**ADDENDUM
NO. 01**

Edwardsburg Public Schools – Middle School and High School Mechanical Upgrades

ADDENDUM NO. 2

PROJECT: **Edwardsburg Middle School – Mechanical Upgrades**
69410 Section St.
Edwardsburg, MI 49112

FIRST FLOOR SHEET METAL PLAN - UNIT B

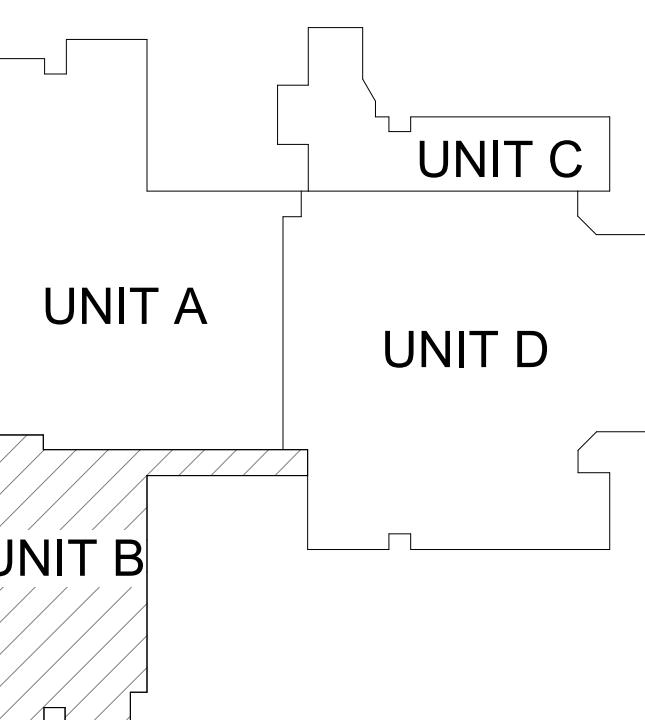
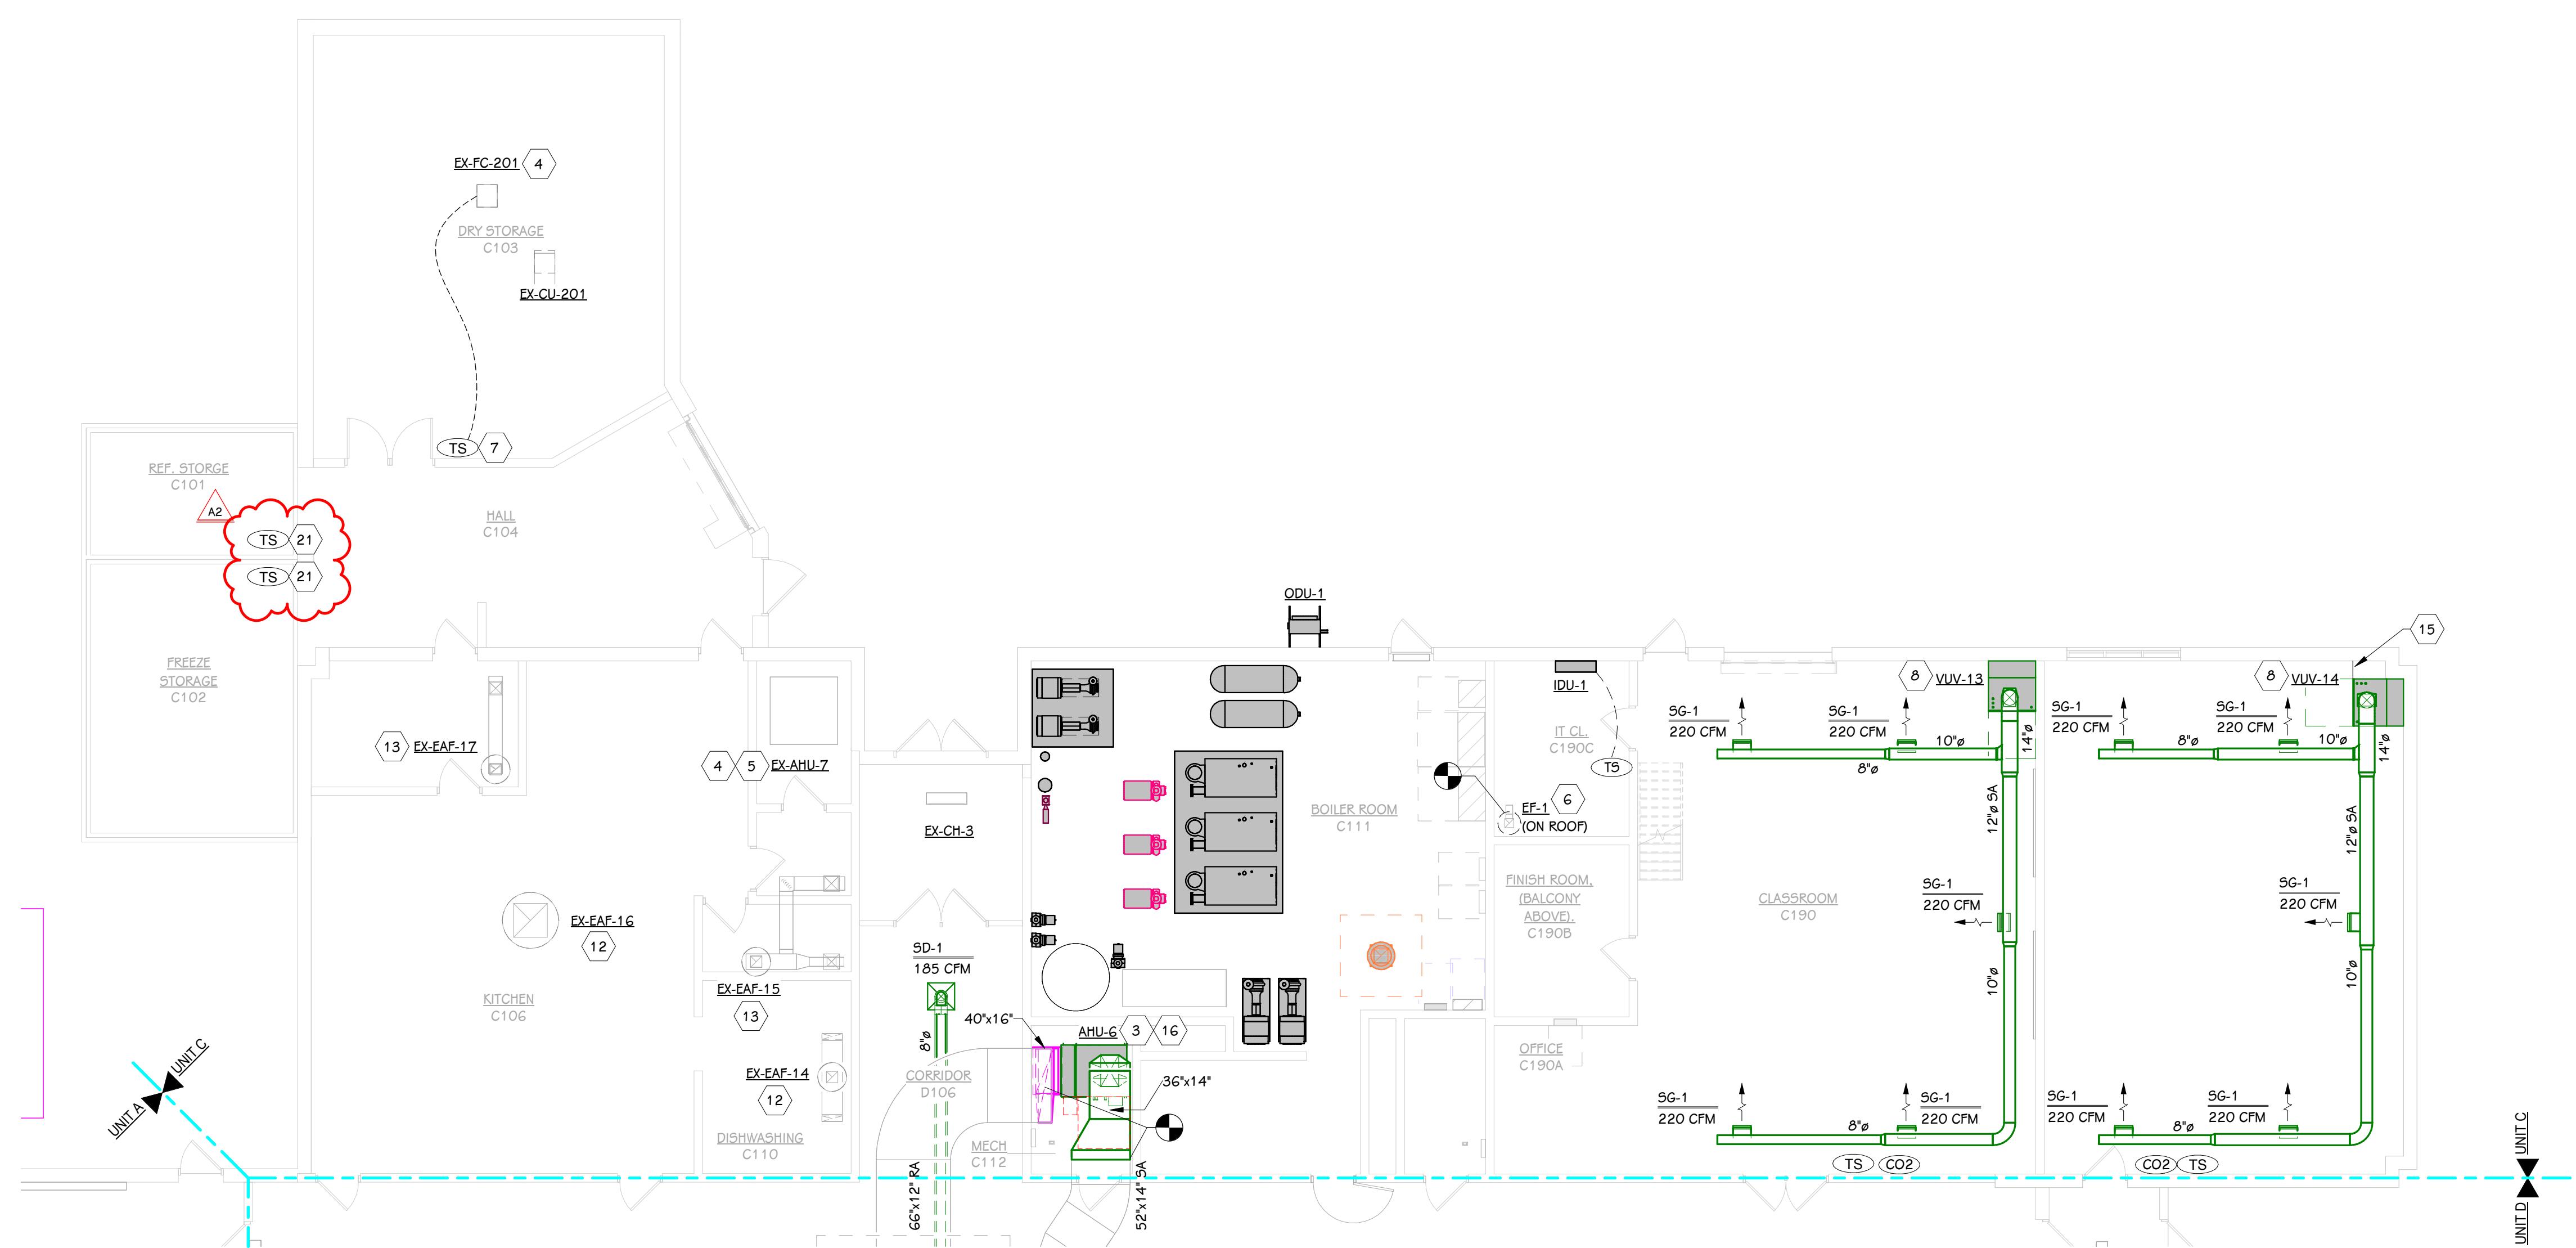
M 101, M 101A, M 101B, and M 101D – Updated diffusers & grille location based revised ceiling grids.

SHEET TITLE FIRST FLOOR SHEET METAL PLAN - UNIT C
SHEET NUMBER M 101C
DATE JANUARY 16, 2026
21-201.041

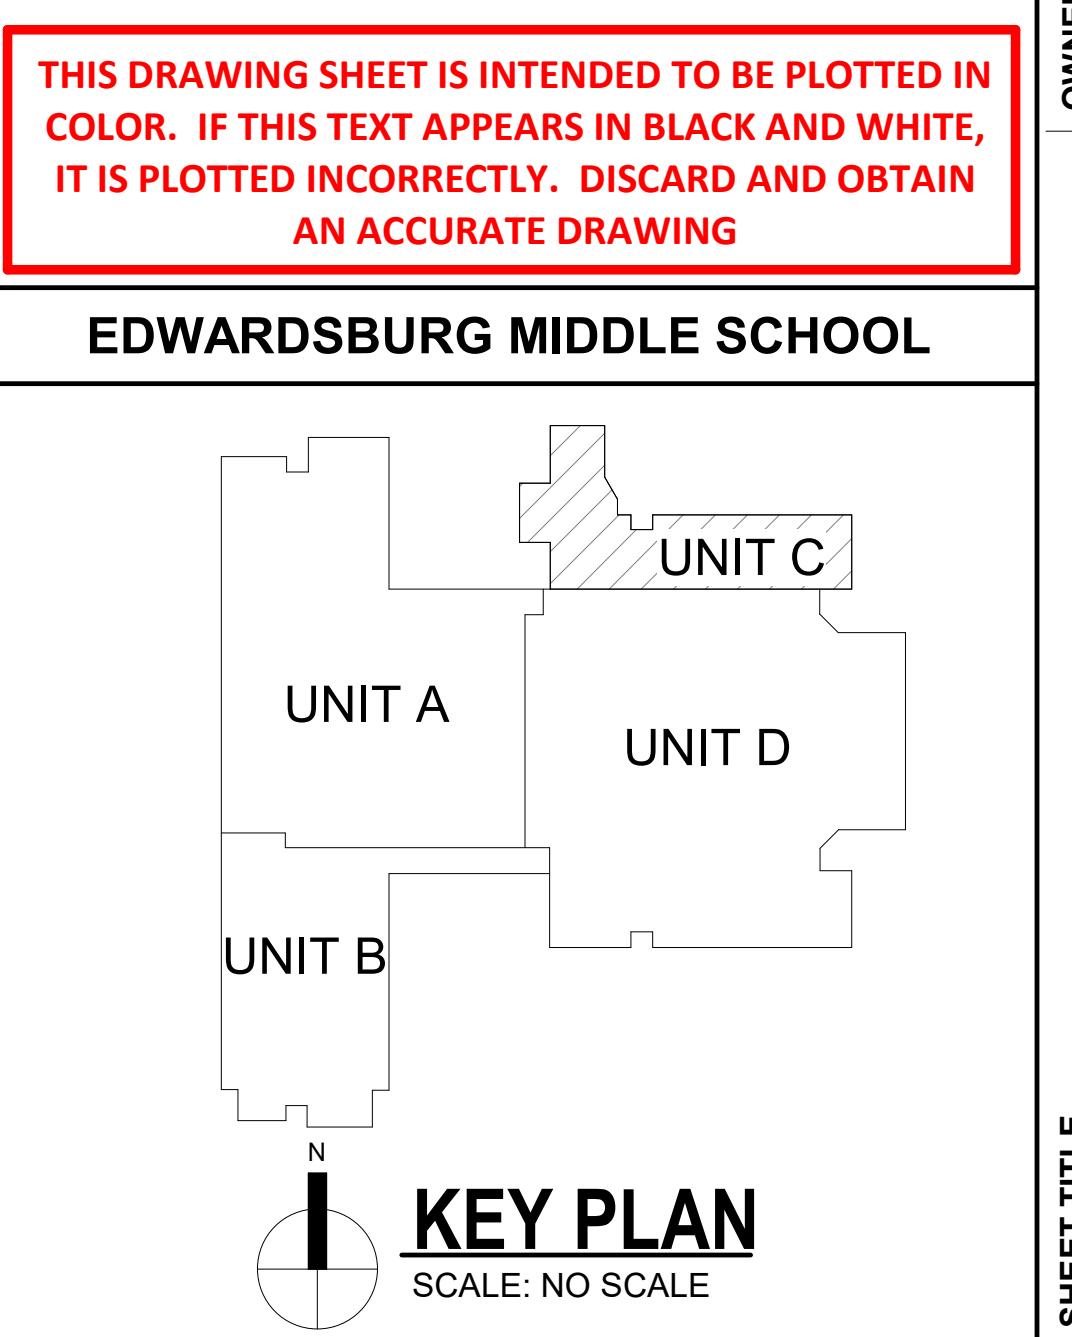
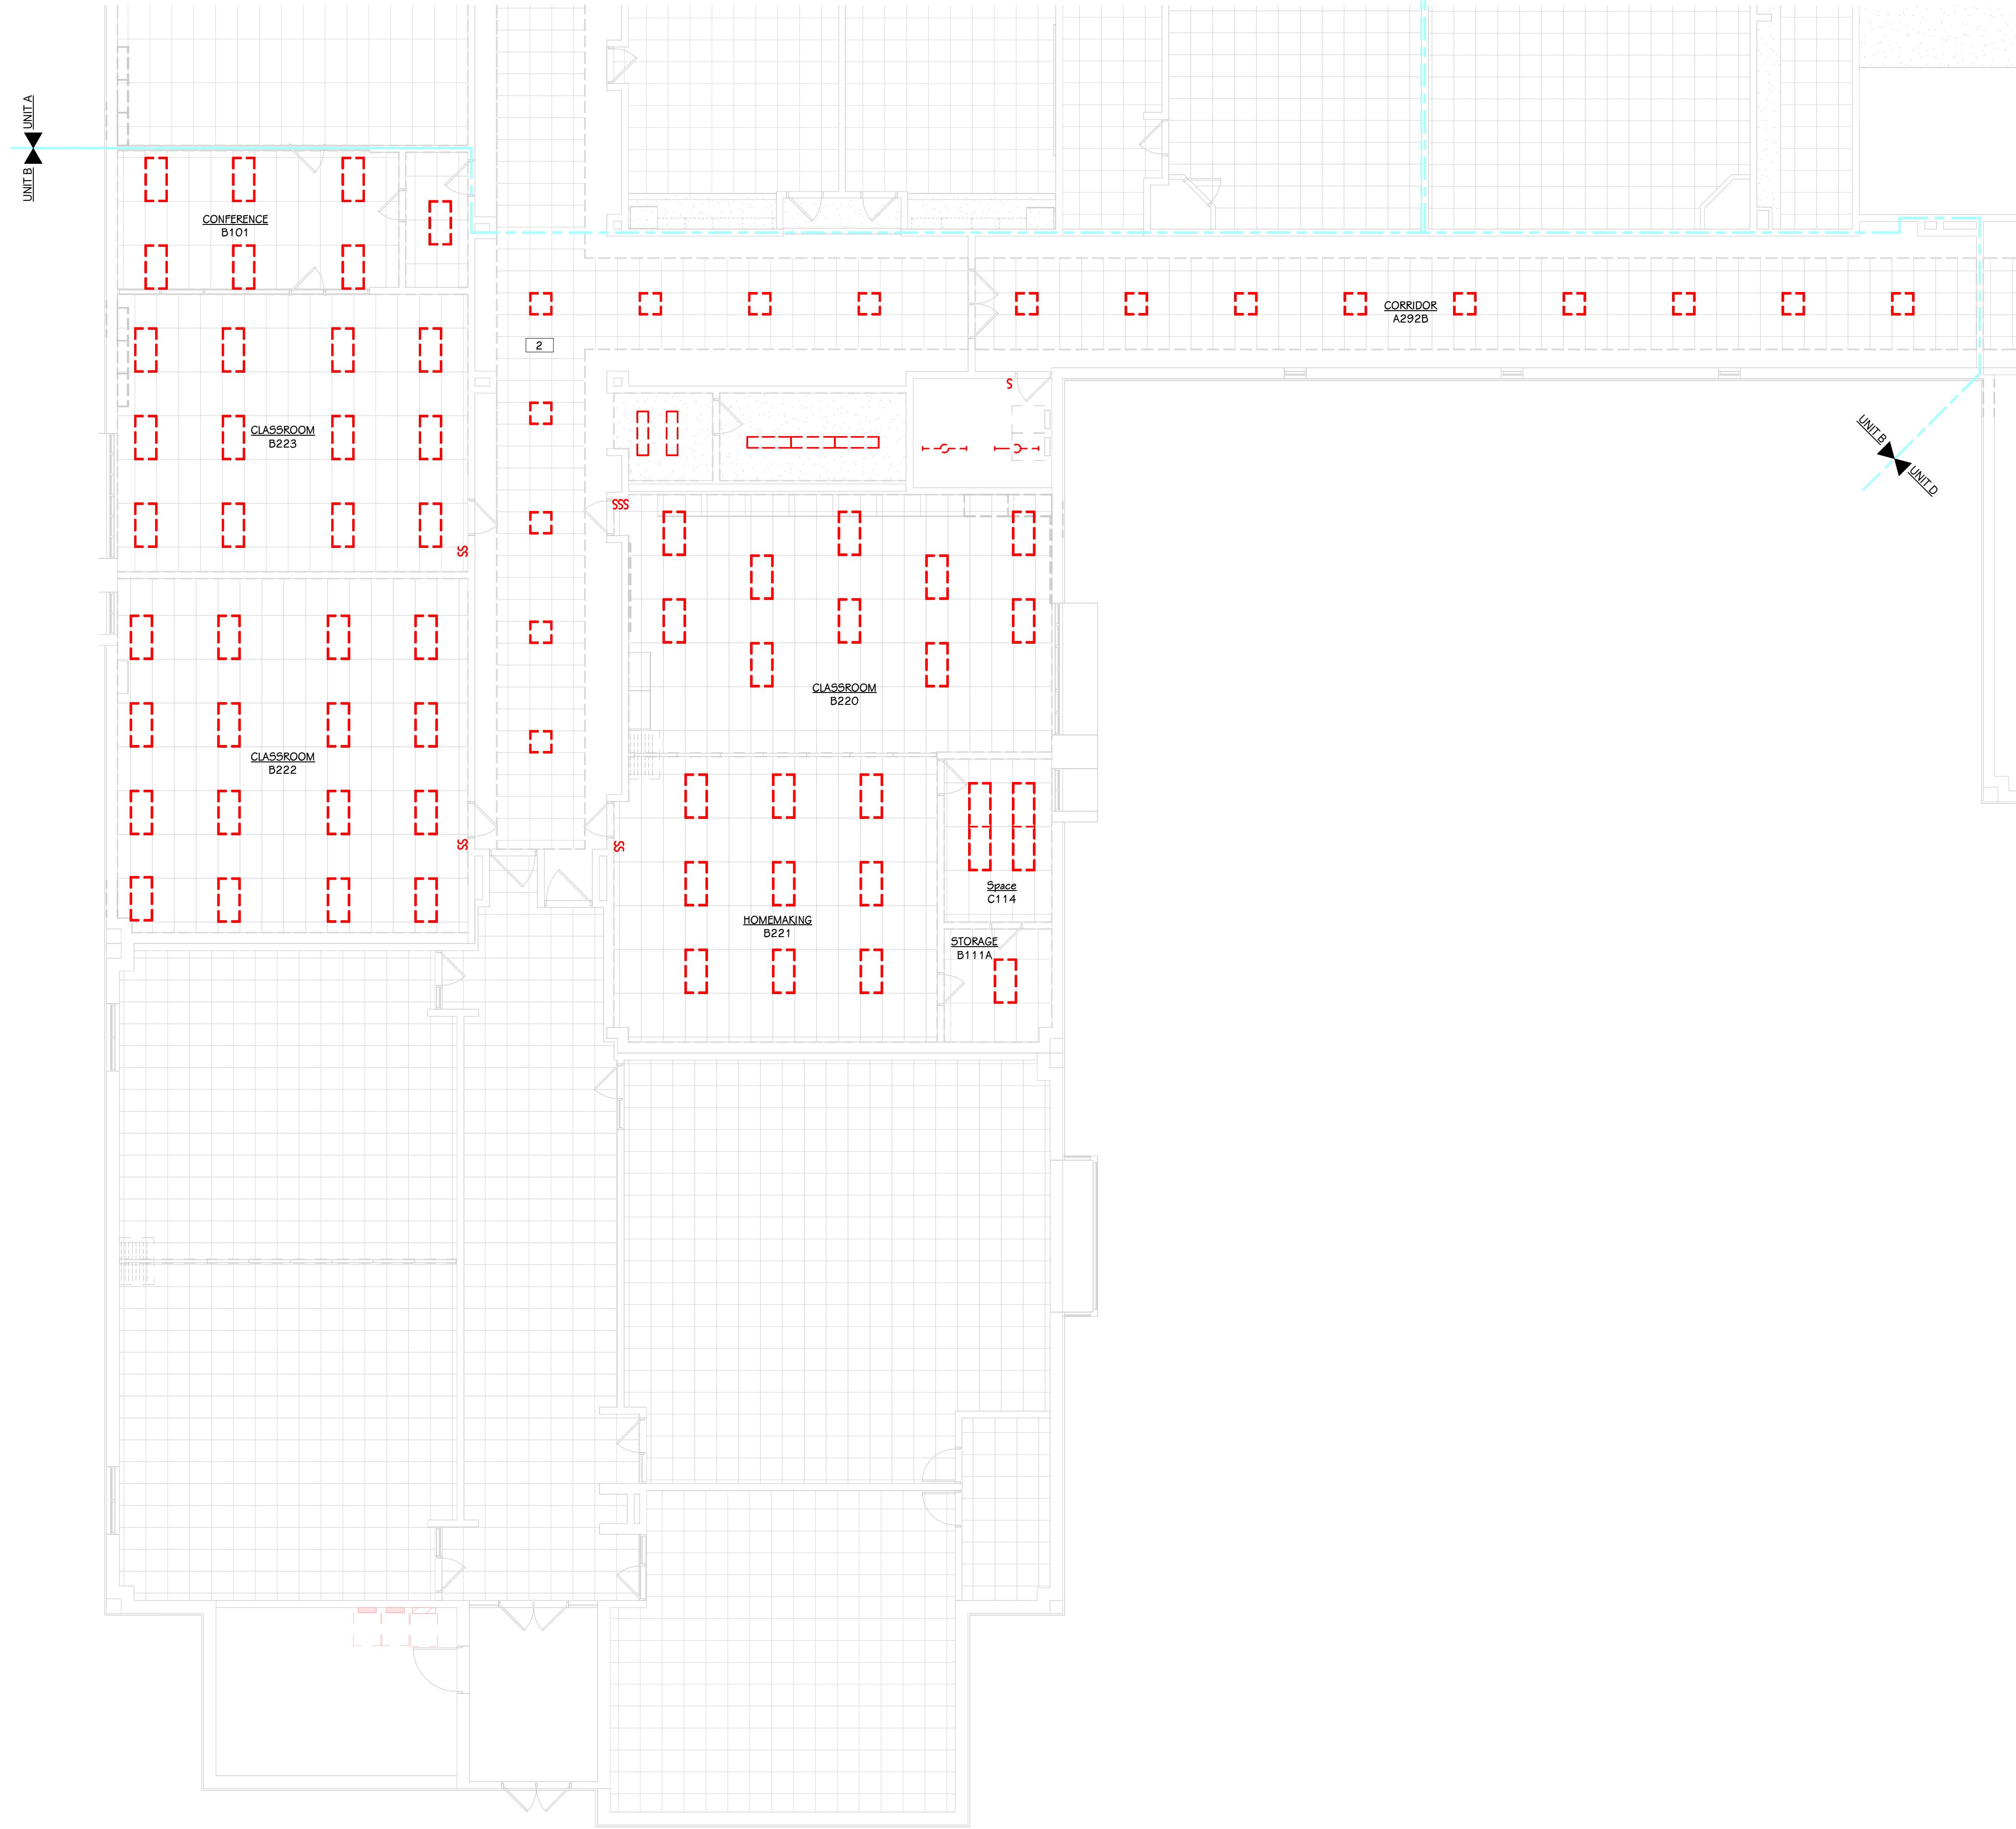
M 101C – Added temperature sensor with walk-in freezer and cooler.
